**DOCKET NUMBER 50-483  
UNION ELECTRIC COMPANY  
CALLAWAY PLANT**

**TECHNICAL SPECIFICATION REVISIONS ASSOCIATED WITH THE  
STEAM GENERATOR REPLACEMENT PROJECT**

**Responses to NRC Request for Additional Information on  
WCAP-16265-P, Rev. 0, "Callaway Replacement Steam  
Generator Program NSSS Licensing Report"**

**TAC No. MC4437**

Figure 1 Callaway GOTHIC Containment Model for MSLB Events

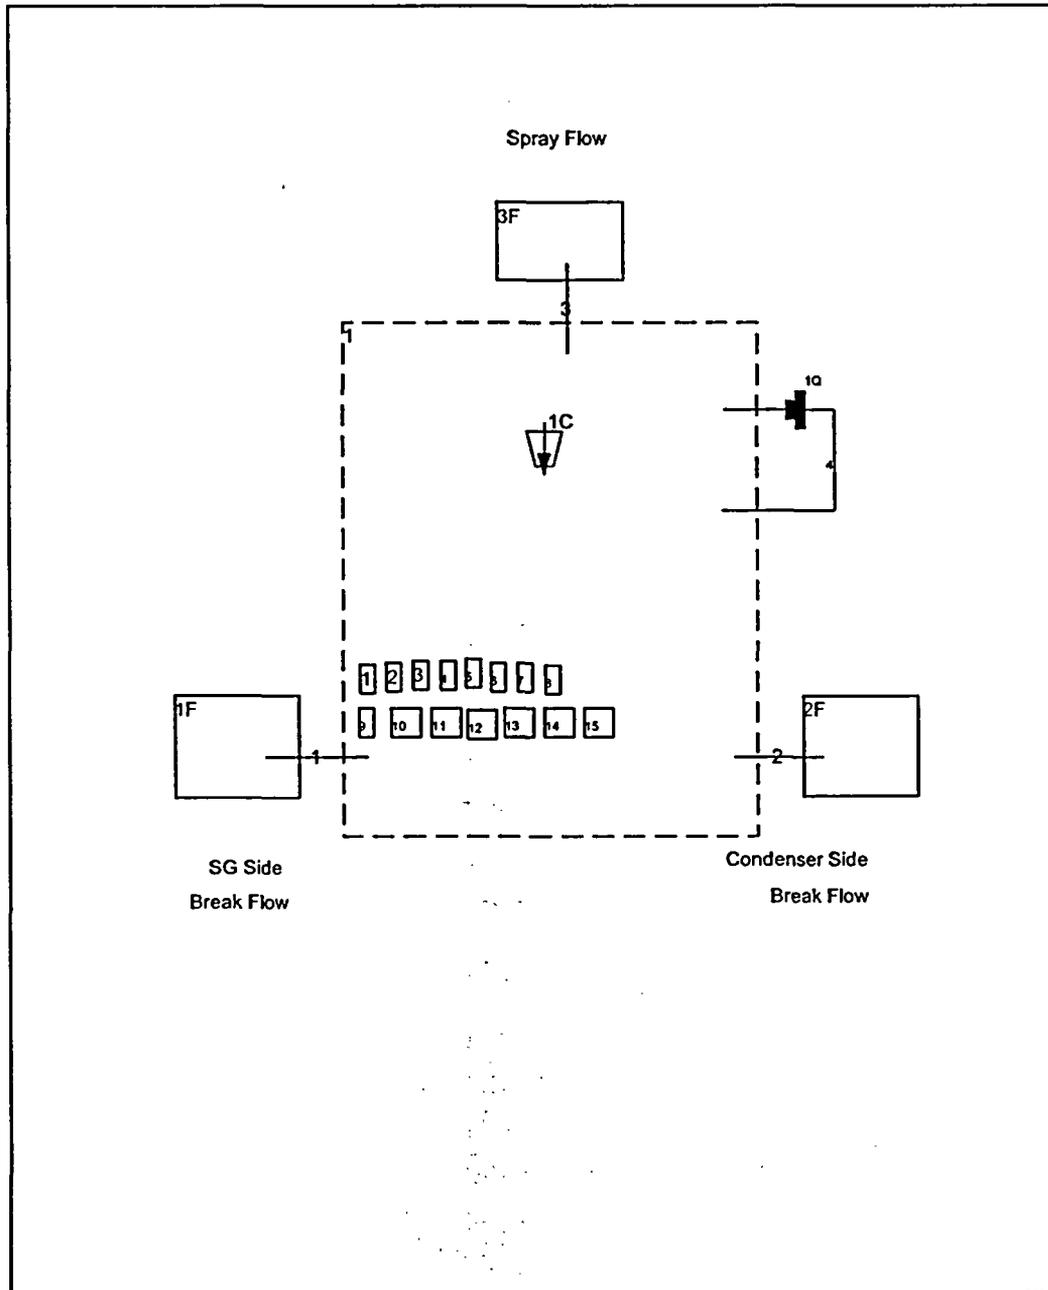
2. Discuss and describe the containment model used for the containment integrity calculations for Callaway, including the following (subroutines in the GOTHIC 7.0 manual may be referenced, if appropriate):
  - a. Noding (if more than one node, provide noding diagram).

The Callaway GOTHIC containment model for a MSLB event is shown in Figure 1. The containment (Volume 1) is modeled with a single lumped parameter node. Two boundary conditions (1F and 2F) are used to represent the sources of mass and energy from the break. The spray injection system is modeled with boundary condition (3F). Flow paths connect the boundary conditions to the containment volume. Fifteen heat sinks and a fan cooler component are also shown.

Figure 3 Fan Cooler Heat Removal Rate per Train

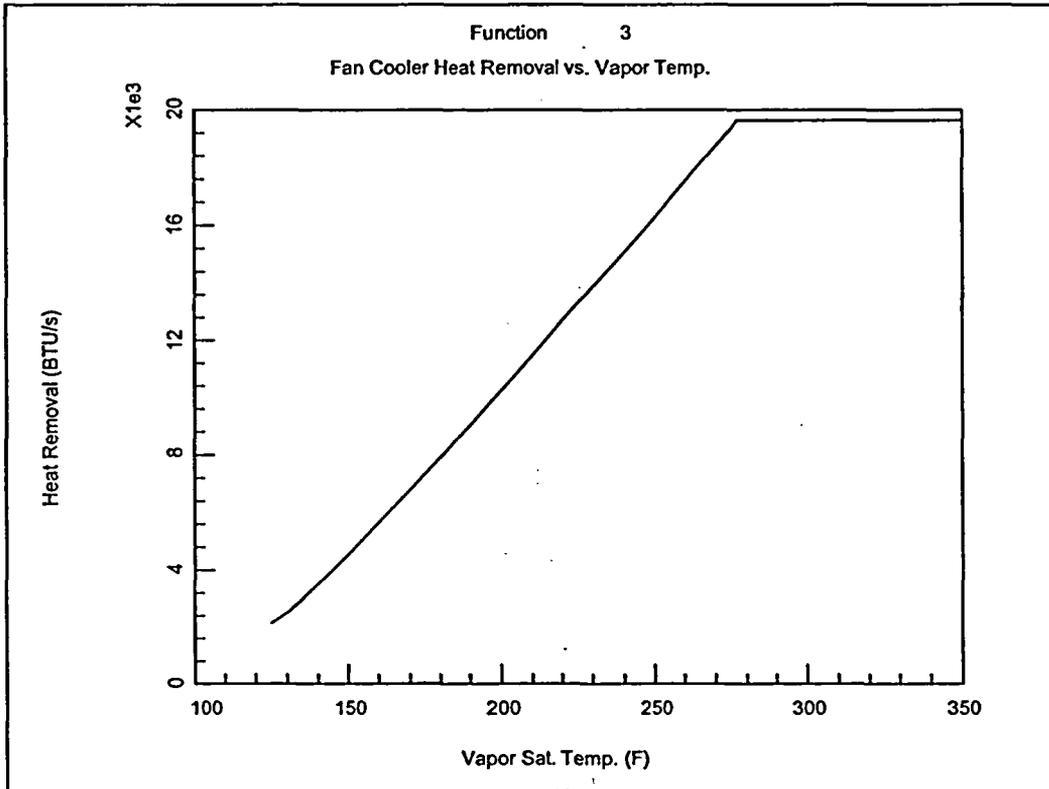
e. Modelings of the containment spray (including drop size assumption) and fan coolers.

The containment fan coolers are modeled with a cooler component. There are two fan coolers per train and two trains are normally available. The fan coolers in the containment evaluation model are modeled to actuate after the containment HI-1 setpoint (6 psig) is reached and begin removing heat from containment after a specified 60 second delay. The fan cooler heat removal rate per train is given as a function of containment temperature in the Callaway CONTEMPT containment model and is shown in Figure 3. This represents a 34% reduction in the original fan cooler heat removal capability. The heat removal rate is read into a GOTHIC function and a multiplier, based on the number of fan cooler trains running, is used to calculate the heat removal rate from containment.
